## Groundwater Transfer Review Summary Form

Transfer/PA # T- 12359

Application: T-12359

Applicant Name: Rattlesnake Creek Land & Cattle

Weaver Springs area Hydrograph

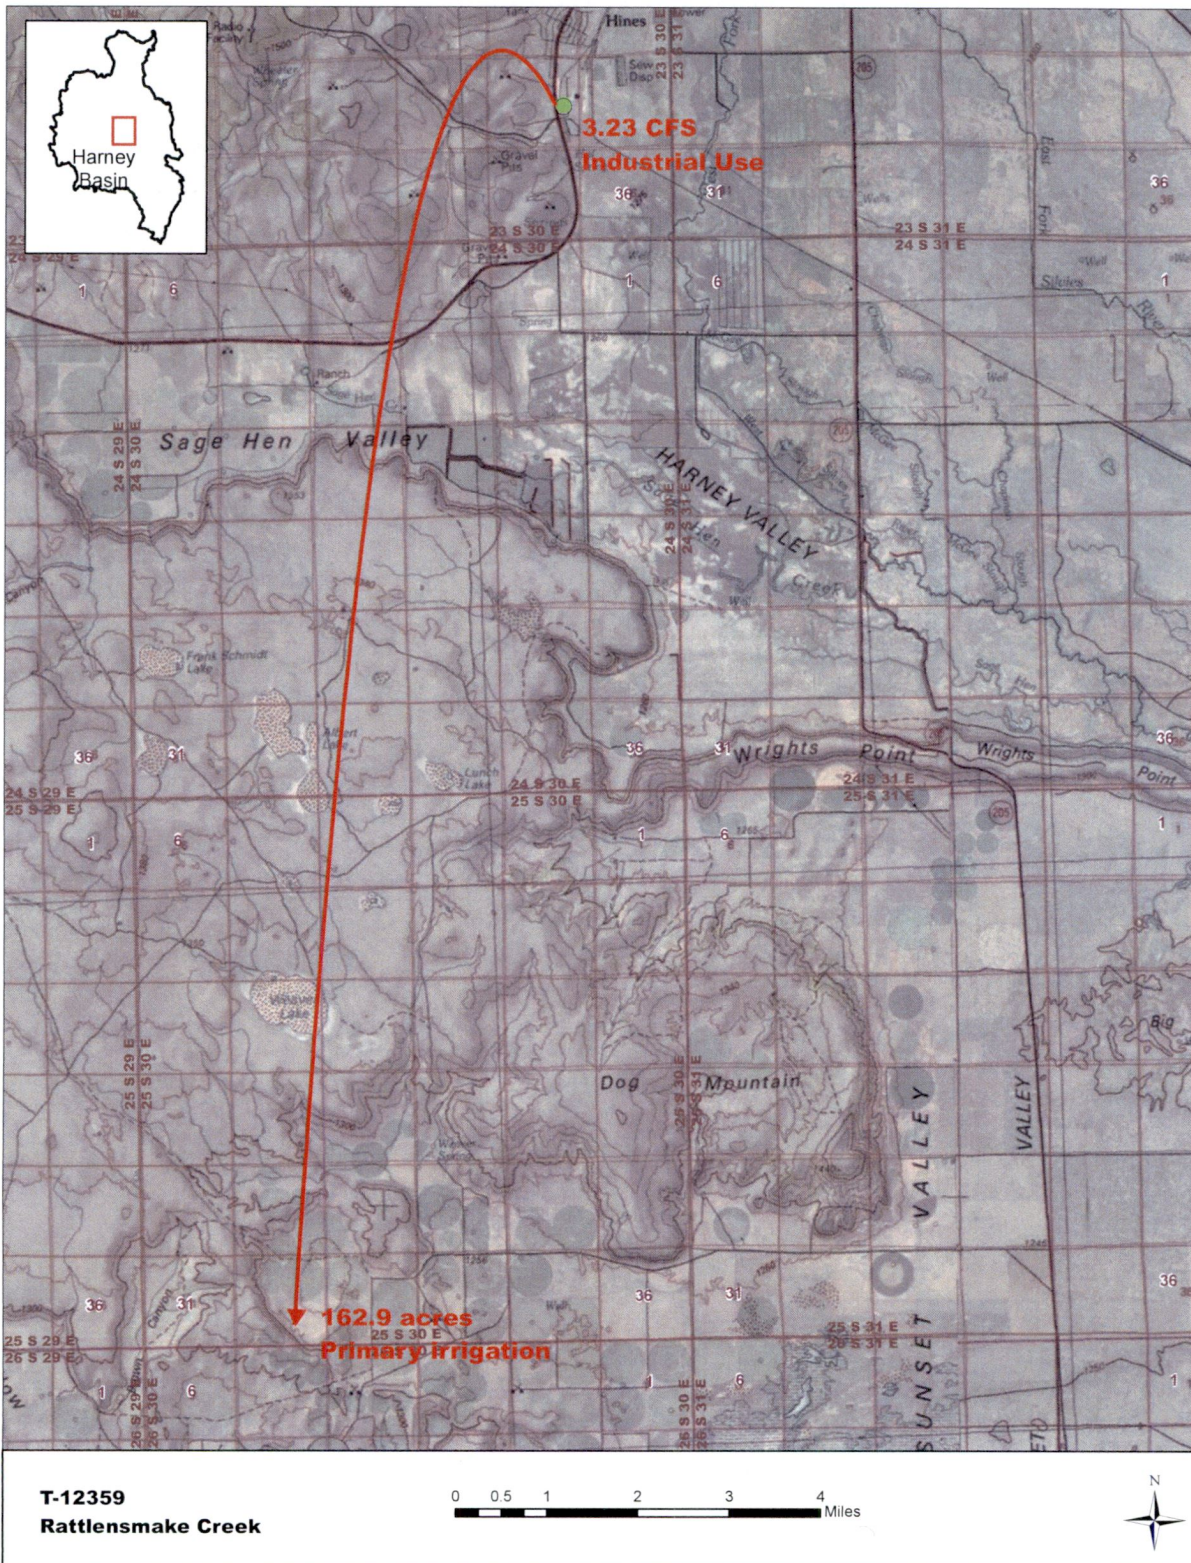
The proposed APOAs are located ~12 miles south of the currently authorized well. Consequently, groundwater withdrawals at this proposed location will result in an increase in interference with groundwater rights near that location. Additionally, the proposed APOAs are located in the Weaver Springs area; an area within the Harney Basin that has well documented year-to-year water level declines. The declines documented in the Weaver Springs area are up to 5 feet and greater per year since the late 1990s – the highest rate of decline of any area in the Harney Basin.

- b) If yes, would this proposed change, at its maximum allowed rate of use, likely result in another groundwater right not receiving the water to which it is legally entitled?  
☒ Yes ☐ No If yes, explain: The proposed use will result in additional water level declines in the Weaver Springs area. Existing junior rights in this area have decline conditions, which will be triggered earlier if this transfer is approved. All existing groundwater users in this area will be negatively impacted by any increased authorized groundwater pumping.

6. What conditions or other changes in the application are necessary to address any potential issues identified above: none.
7. Any additional comments: Analysis of Landsat imagery clearly indicates that the proposed POU has been irrigated without the benefit of a water right since 2014, contributing to the long term year-to-year water level declines in this area.
